## Certificate of Appropriateness Case Report

*Filing Date:* April 28, 2011  
*Case No.:* **2011.0417A**  
*Project Address:* **2 HARRISON STREET**  
*Historic Landmark:* No. 157 – Hills Brothers Coffee Plant  
*Zoning:* RH-DTR Zoning District  
84-X/105-X Height and Bulk District  
*Block/Lot:* 3744/005  
*Applicant:* Steve Kelley  
MKThink  
Roundhouse One, 1500 Sansome Street  
San Francisco, CA 94111  
*Staff Contact* Richard Sucre - (415) 575-9108  
richard.sucre@sfgov.org  
*Reviewed By* Timothy Frye – (415) 575-6822  
tim.frye@sfgov.org

Mozilla – San Francisco Office TI  
2 Harrison Street, 7<sup>th</sup> Floor  
San Francisco, CA 94111

**VIEW FROM PIER #14 ACROSS THE EMBARCADERO**

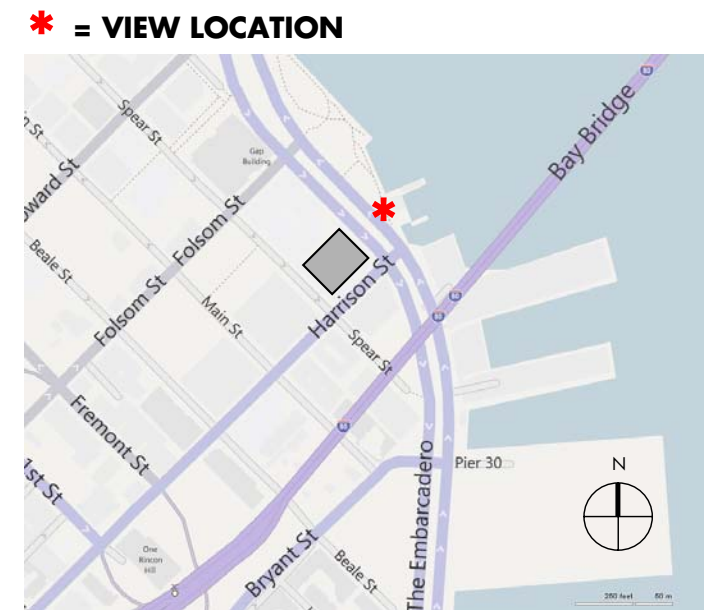
PROPOSED LOCATION OF NEW ROOF DECK. ALL 7<sup>th</sup> FLOOR PENTHOUSE IMPROVEMENTS TO REMAIN BELOW EXISTING PARAPET, OUT OF VIEW FROM THE STREET BELOW, TYP.

**EXISTING ELEVATION ALONG THE EMBARCADERO**

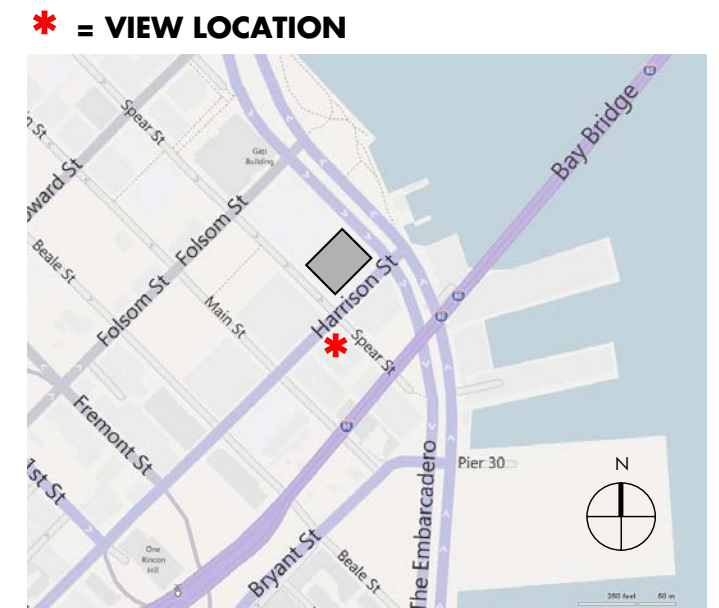
PROPOSED LOCATION OF NEW ROOF DECK BEHIND EXISTING ROOF PARAPET; NO CHANGES TO EXISTING HISTORICAL BRICK FAÇADE, TYP.

**STREET VIEW – HARRISON @ SPEAR ST.**

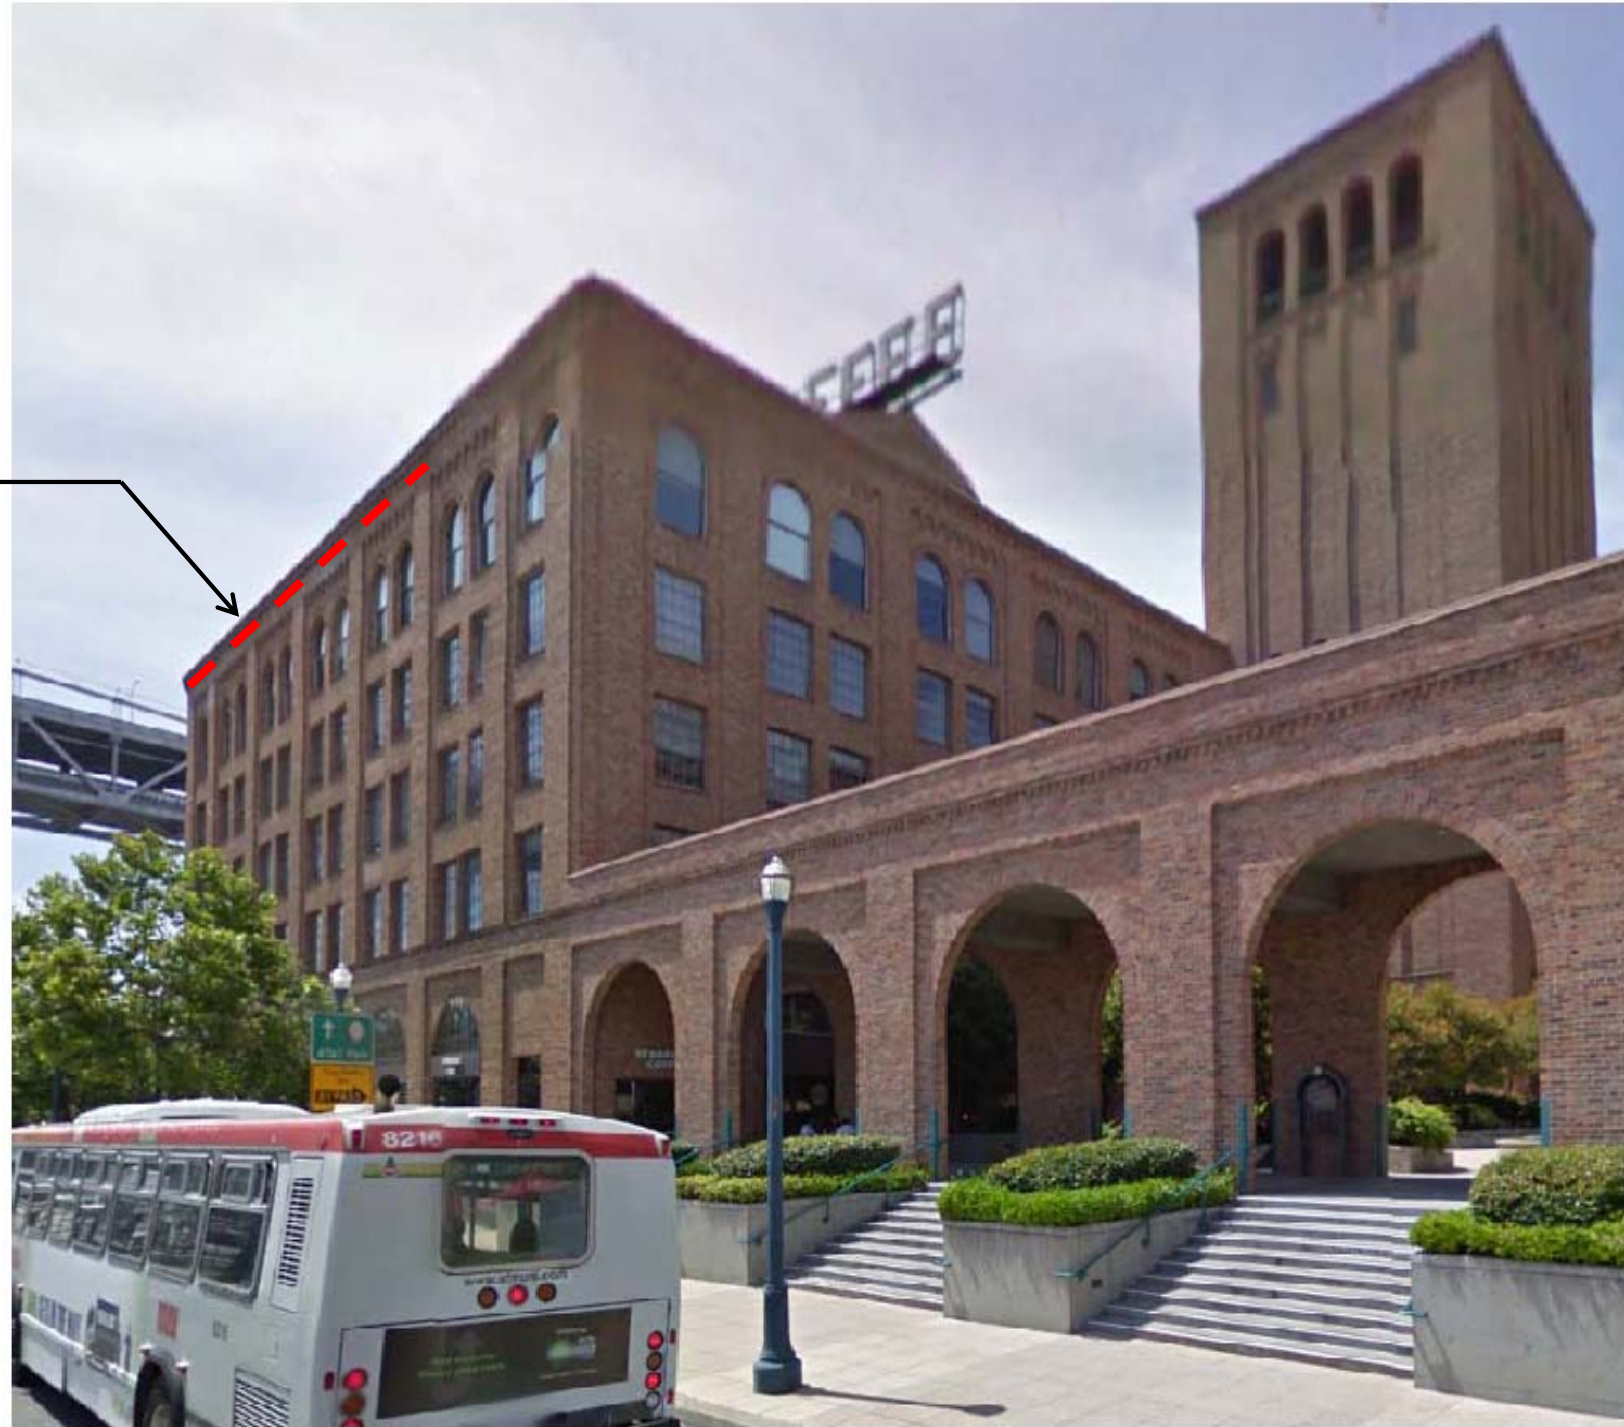
PROPOSED LOCATION OF NEW ROOF DECK BEHIND EXISTING ROOF PARAPET; NO CHANGES TO EXISTING HISTORICAL BRICK FAÇADE, TYP.
